FORWARDING REQUEST FOR RELIEF FROM AN ASME CODE SECTION IX TESTING
REQUIREMENTS, PURSUANT TO 10CFR50 & 50.55A, CONCERNING TESTING OF A WELD ON A
PIPE CONNECTED TO THE MAIN STEAM SYSTEM AT SUBJECT FACILITY. W/ATT SKETCH.

Re: Oconee Nuclear Station
Docket Nos. 50-269, -270, -287

REQUEST FOR RELIEF FROM ASME CODE SECTION XI REQUIREMENT
DETERMINED TO BE IMPRACTICAL

Unit 1 Main Steam (Duke System No. 01A(1))
Weld Number 50 is to be replaced.

ISOMETRIC SKETCH PART IV OF V

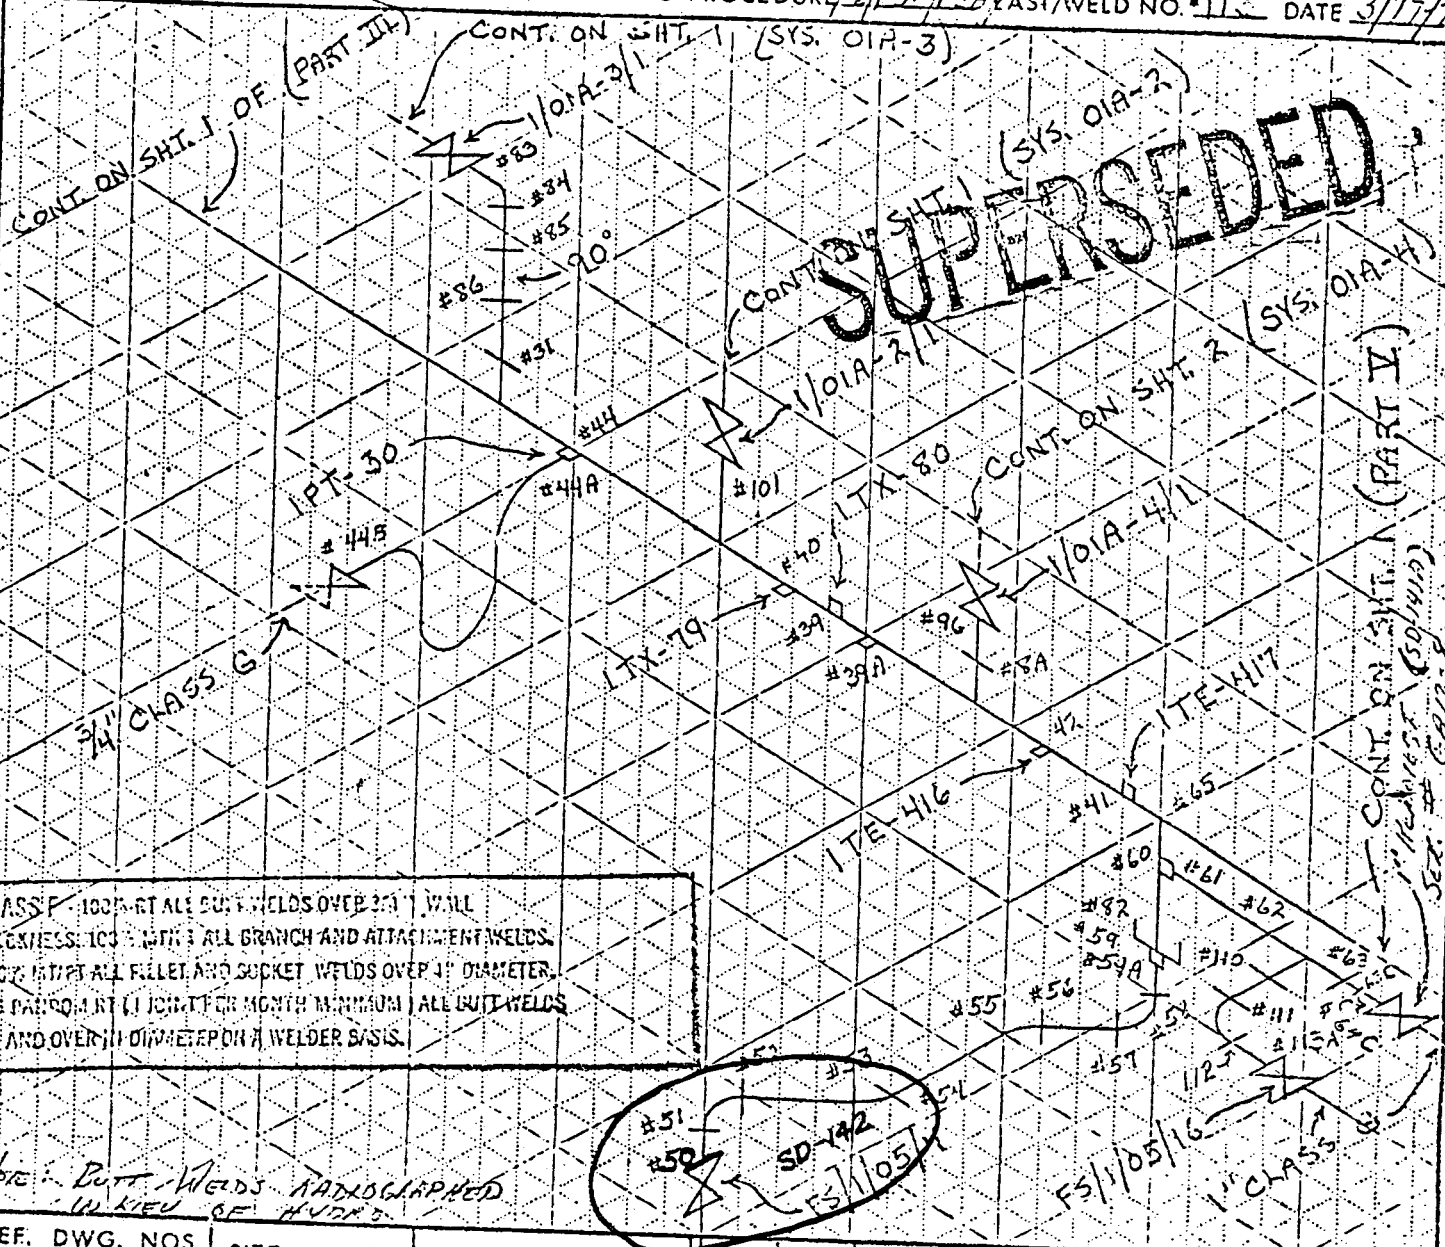
The Main Steam System carries steam energy from the steam generator to the main turbine and associated equipment. The weld to be replaced is a 1" socket weld on the inlet side of a manually operated steam drain valve. (See attached isometric drawing of area of concern)

The weld in question is not directly on the main steam header. Hydrostatic testing of the weld would require pressurizing the OTSG secondary side, main steam lines, and sections of the feedwater header. It would also require heatup of the OTSG and involve operation of many related systems. It is estimated that 7-8 days of down time would be required to perform this hydro. Additionally, the potential for damage is high, as the main steam system is not designed to be filled with water.

There have been no problems in the past with failures of System 01A(1) weld joints of this type. Basically, a hydrostatic test is performed to assure leak tightness of welds and to indicate gross flaws and incomplete work. With one weld involved, it is felt that a system leak test at operating conditions is as reliable as a hydrotest to assure leak tightness.

An examination using the liquid dye penetrant technique along with ultrasonic testing will be performed, and an inservice leak test at operating pressure and temperature will be conducted.
